THE 12-METER TELESCOPE
PROFILE ERROR NEAR SENSOR 6
Comments on MEMO NO. 217

Memo 217 Section 4 "How did it happen?"

Figure 1(d)

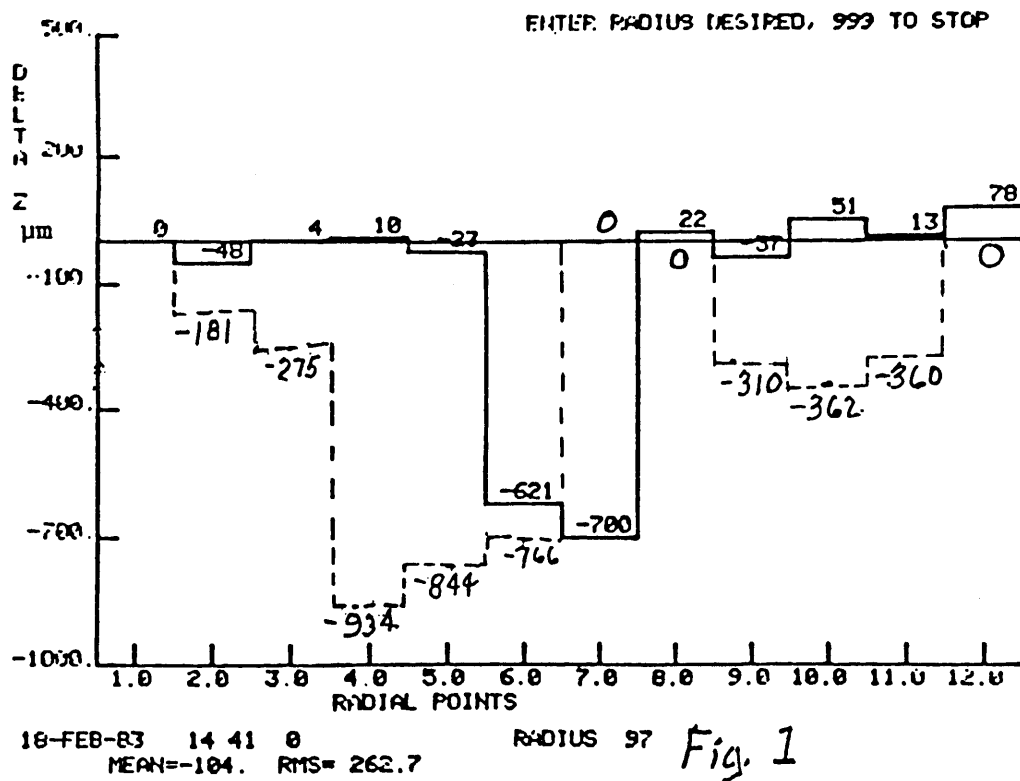
Since it is stated in Section 4 of Memo 217 that the data of figure 2 Memo 217 reveals that the outer panel was not bent much out of shape but that the inner panel was, however, badly bent I did a rather simple transformation of the data of figure 2 for comparison with figure 1(d). The data of the measurement of Oct. 13 of Radius 97 was transformed by rigid body translation and rotation as follows:

- (1) The inner panel was translated up by adding to all readings the amount necessary to place Sensor 1 at the 0 error reading.
- (2) The inner panel is rotated down about sensor #1 by an angle (0.22886°) to make Sensor #7 read Zero. Proportional change of Sensors #2 thru #6 is calculated and applied to those readings.

- (3) The outer panel is translated down by subtracting from all readings an amount necessary to make Sensor #8 read zero error.
- (4) The outer panel is rotated up about Sensor 8 to make Sensor 12 reading Zero through angle of 0.015719° and changes in Sensors 9, 10 and 11 calculated.

Figure 1 following shows figure 1(d) of Memo 217 with the transformed error readings of radius 97 superimposed in dotted line.

It would appear to me that the data on radius #97 taken Oct. 13, 1982 does not show a badly bent panel but does show an effect due to the supports at sensors 3, 5 and 10 not being adjusted at installation to take the gravity deflection out of the panel when it is supported at the end supports.

FIGURE 1

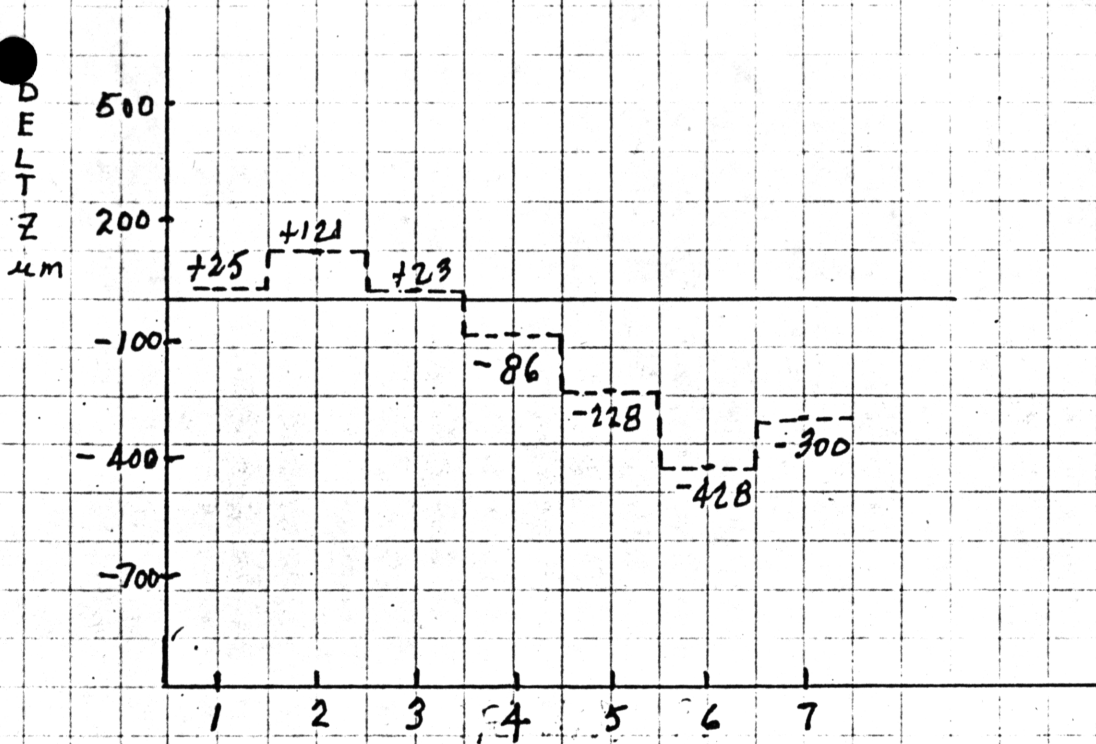
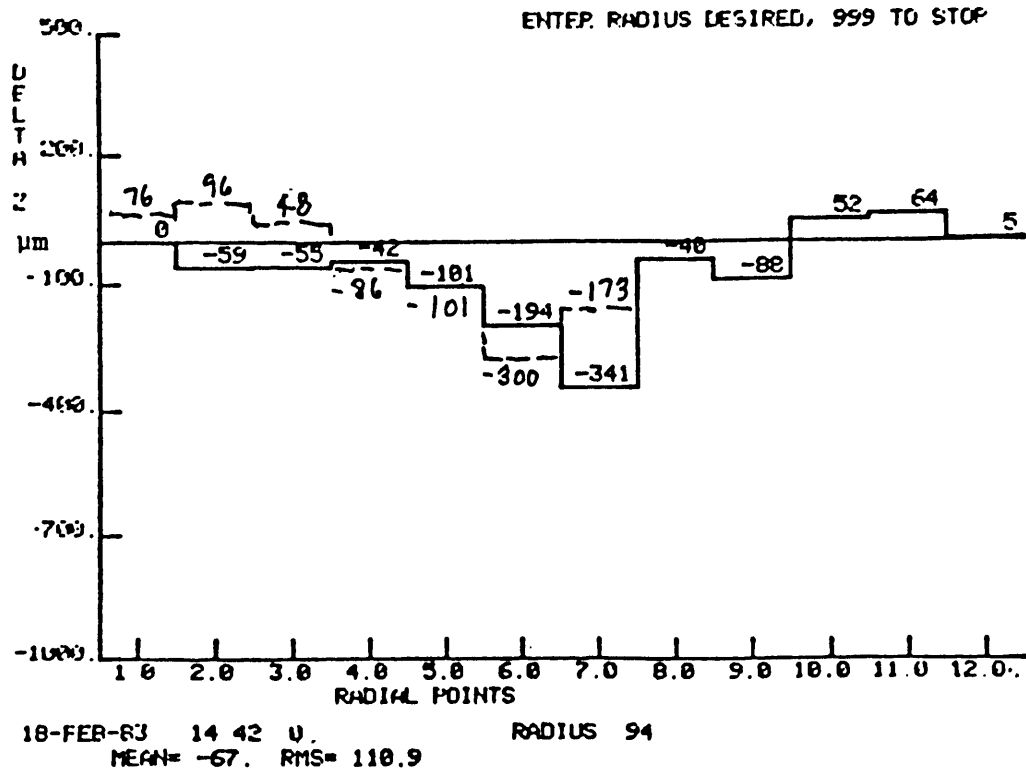
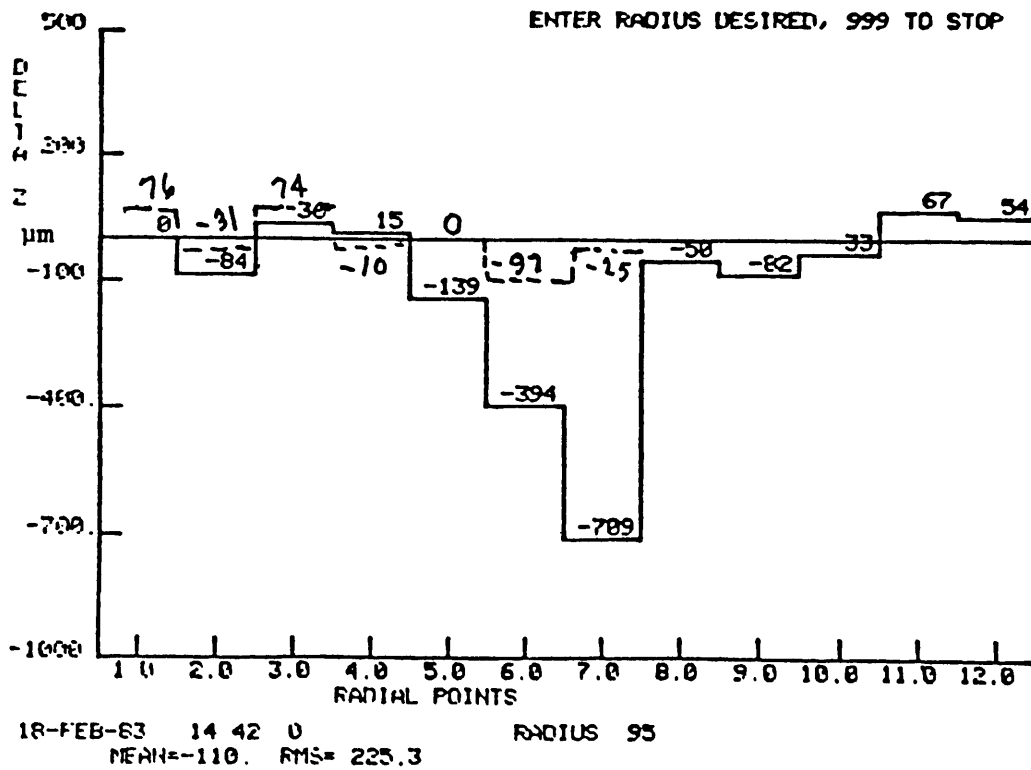
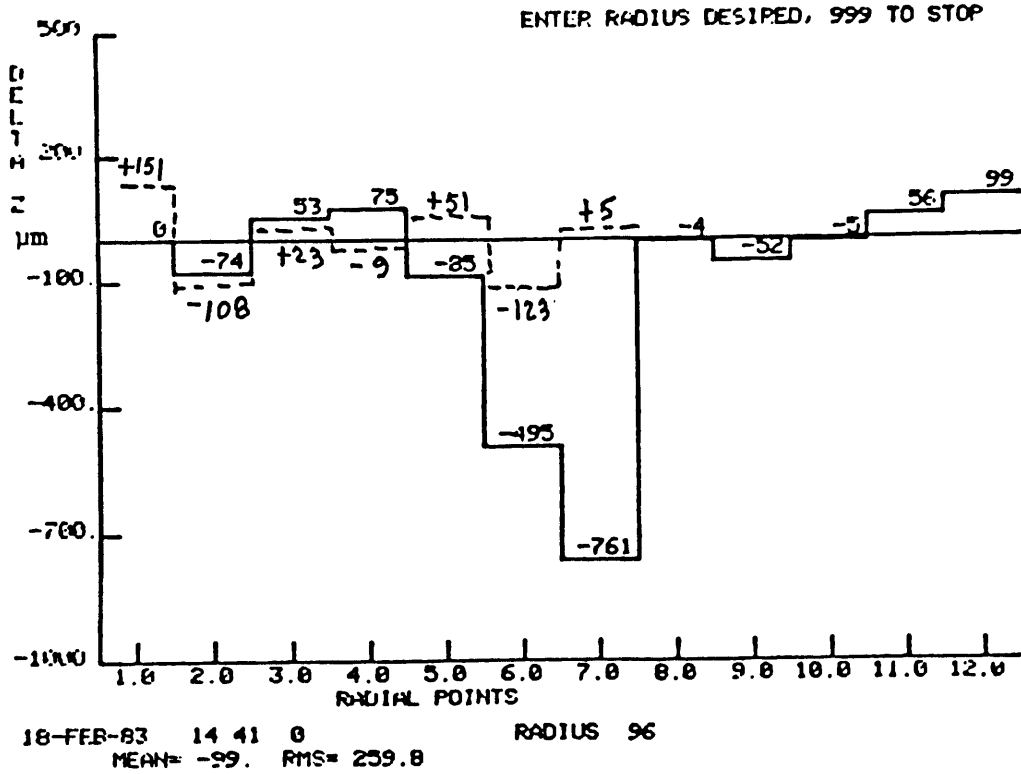
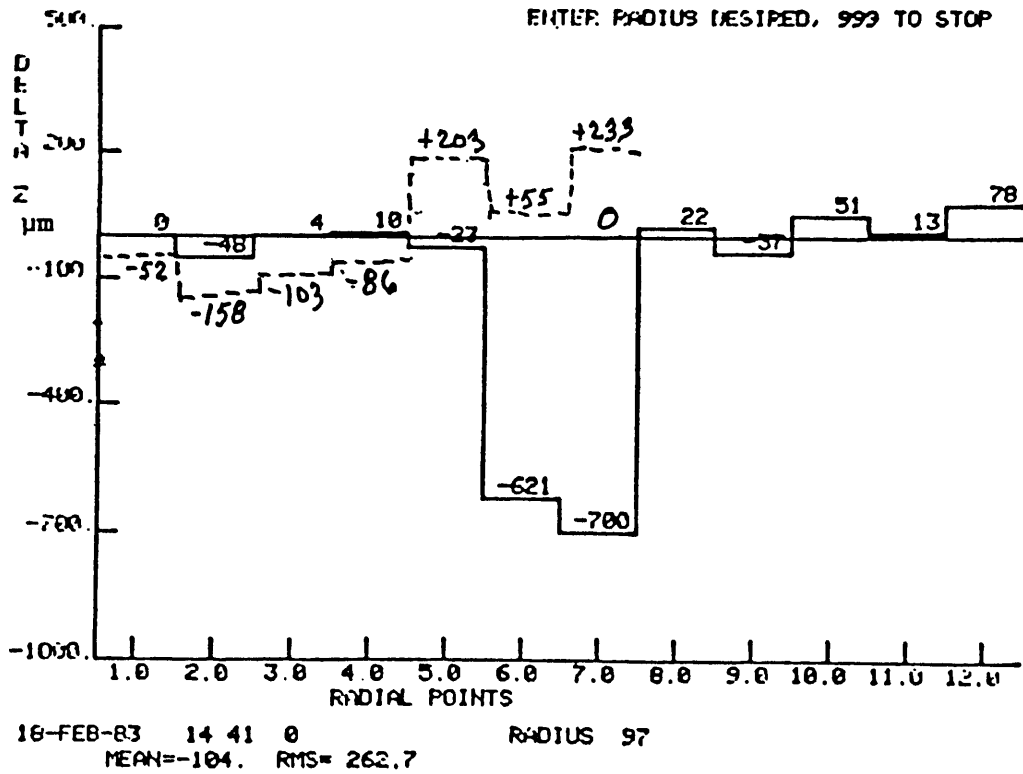
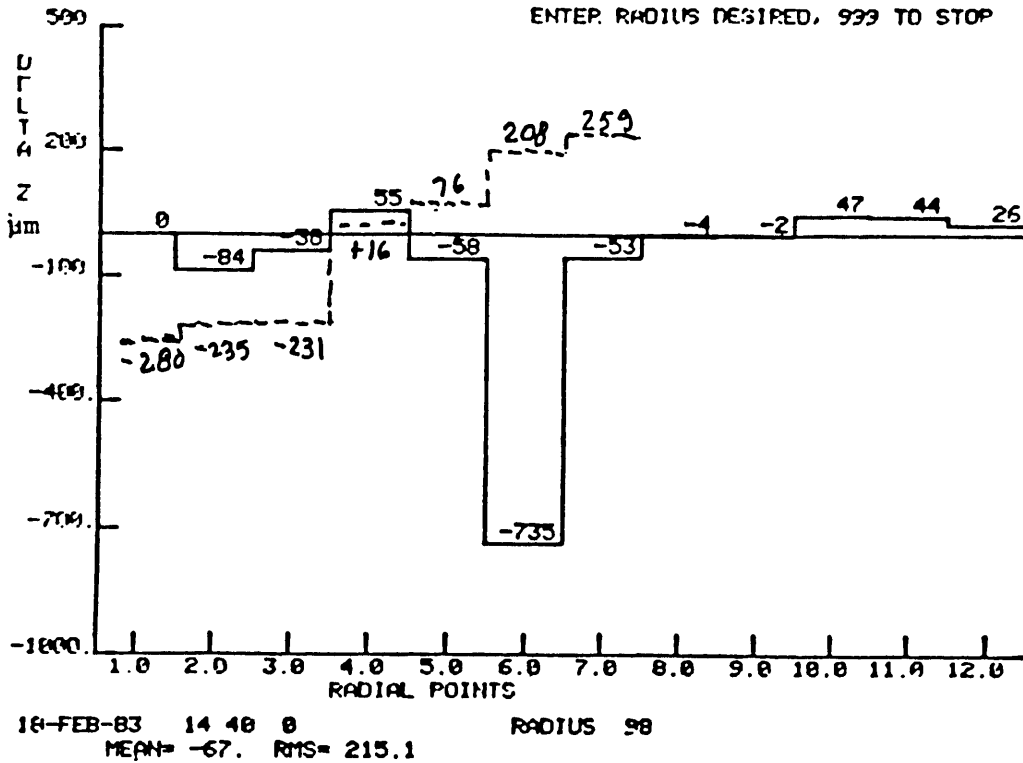
In an attempt to get a clearer picture of the panel as a whole I called Lee King and got the following error readings for radii 93, 94, 95, 96, 97 and 98 which were taken in Oct. 1982 (exact date I didn't get. Since the inner panel was the one I was interested in I only used those.

Since I wanted to transform the panel as a rigid body I took an average of the Sensor 1 readings and an average of the sensor 7 readings to calculate the amount of translation (+2031M) and the amount of rotation (0.158101°) and then calculated the Sensor error value for each sensor in each radii. The transformation was only done in the longitudinal direction. I was later informed by Lee King that the radii numbering might have been changed but since Memo 217 indicates that Radii 97 of Oct. 13 is the same as Radii 97 of 18 Feb. I have used the radii as being the same. Following is a plot on Figures 1 (a) through 1 (e) of the transformed data of Oct. 1982 plotted in dotted line on Radii 94 through 98 of Feb 19, 1983. I have included a plot of Radius 93 since it was not included in Memo 217. Again I am not sure that these reading clearly indicate that a badly bent panel existed in Oct of 1982.
